Changelog:

Chrysler CCD/SCI Scanner		
ChryslerCCDSCIScanner_V144		
2020. 08. 30. 9:01		László Dániel
Sheet: 1/1	A2	Rev: V1.44

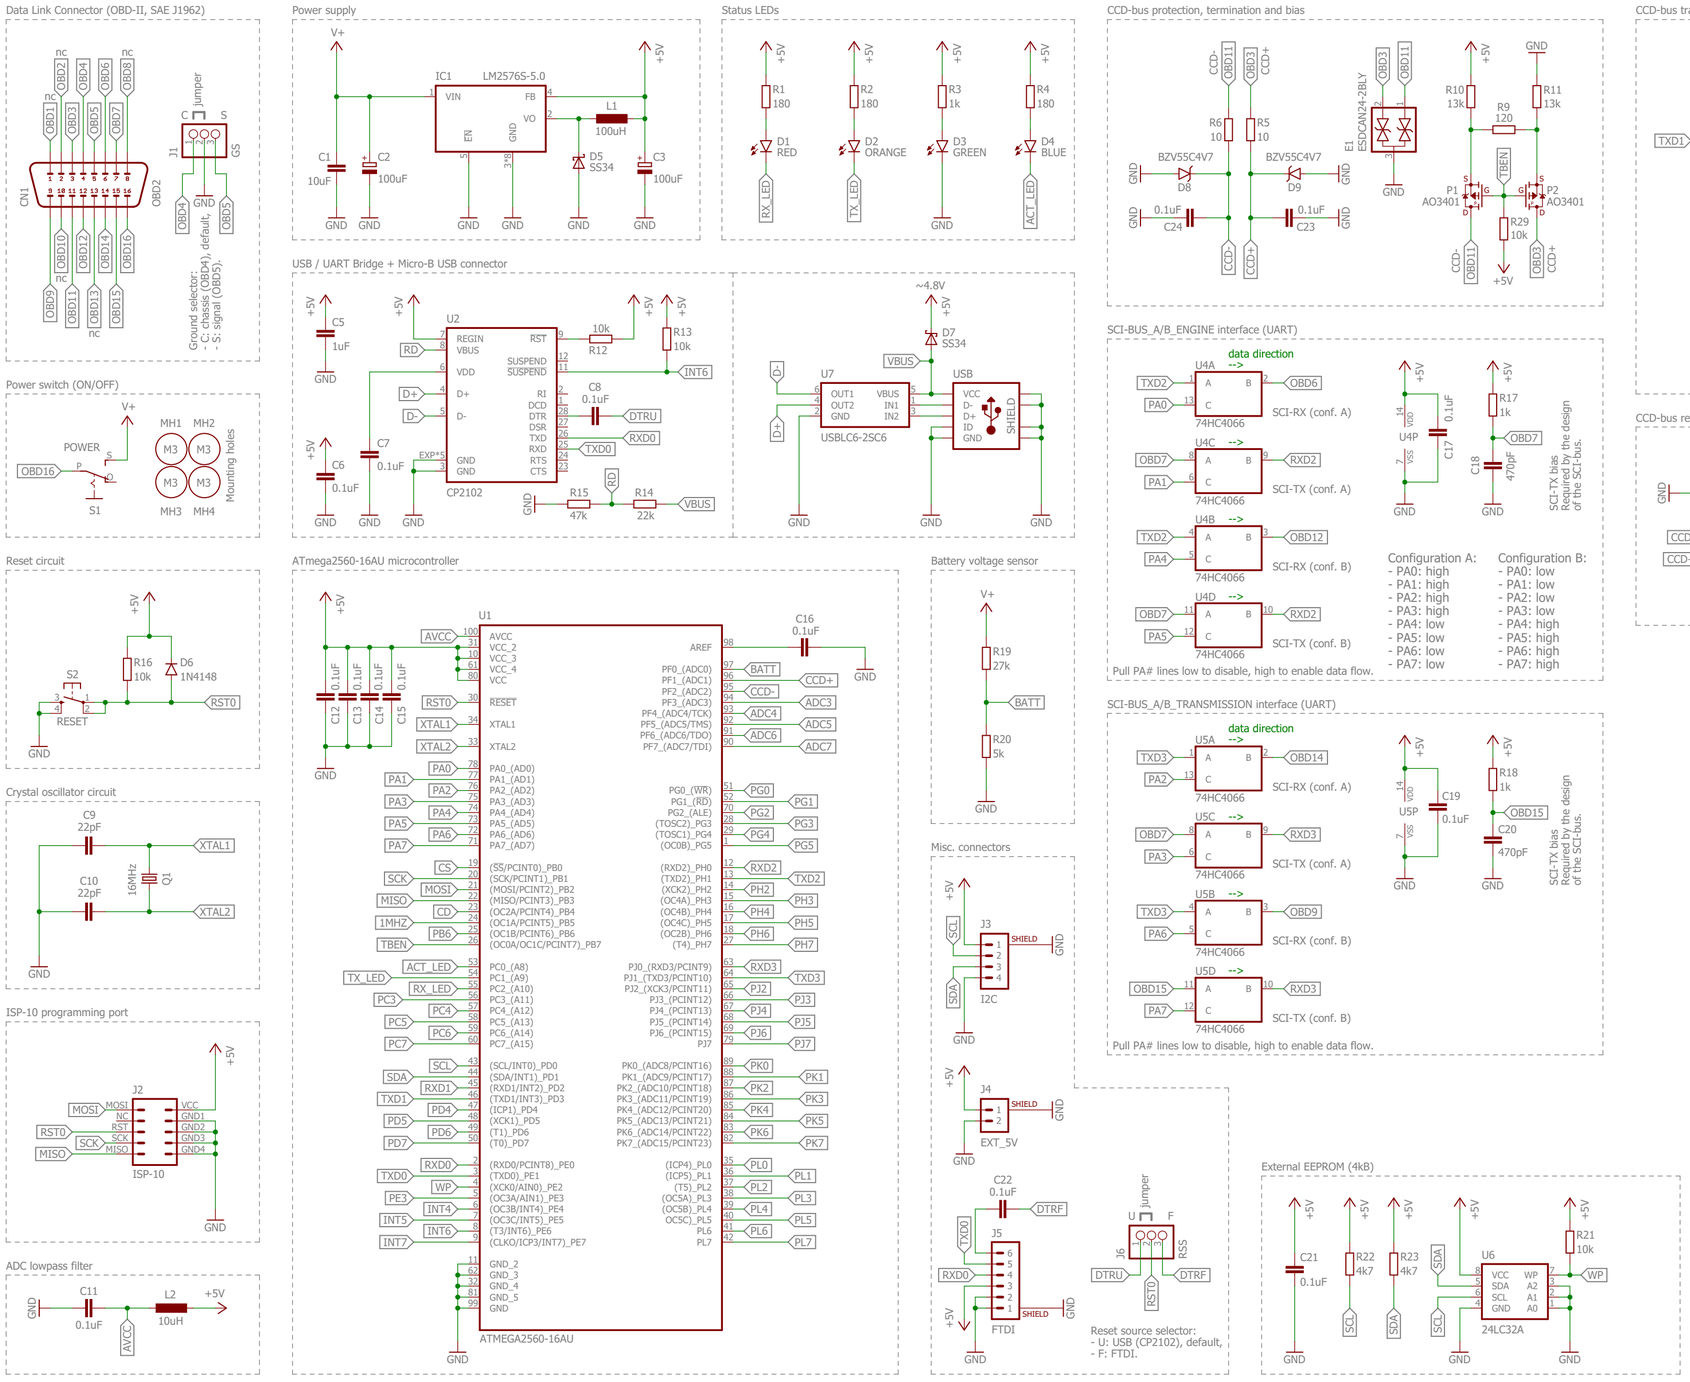
V1.41:
- replace: SMD USB connector with through-hole variant,
- add: FTDI-connector (J7); CP2102 is hard to solder, FTDI programming is a good alternative,
- replace: through-hole C2 and C3 capacitors with SMD-variant,
- components moved around and routing changed to optimize layout.

V1.42:
- replace: J6 (EXT_5V) connector with SMD-variant,
- replace: J7 (FTDI) connector with SMD-variant.

V1.43:
- improve: FTDI/USB (CP2102) programming auto-reset circuit is selectable by the new J8 jumper,
- add: C22 capacitor for FTDI auto-reset, defaults to USB (CP2102) auto-reset,
- add: D8 and D9 Zener-diodes (3.3V) for additional CCD-bus protection against voltage transients.

V1.44:
- improve: CCD-bus transceiver completely re-designed and it no longer uses the CDP68HC68S1E chip; an N/P-channel dual mosfet (U3) and voltage comparator (U8) took its place,
- improve: CCD+ and CCD- pins are routed to analog inputs of the ATmega2560 to measure bus-voltages,
- improve: CCD-bus termination and bias resistor jumpers replaced by P-MOSFET switches (P1, P2) controlled by the ATmega2560,
- replace: D8 and D9 Zener-diode values increased to 4.7V; previous lower value (3.3V) may interfere with the CCD-bus wake-up signal (3.5V minimum),
- add: E1 ESD-protection diode for additional CCD-bus protection.
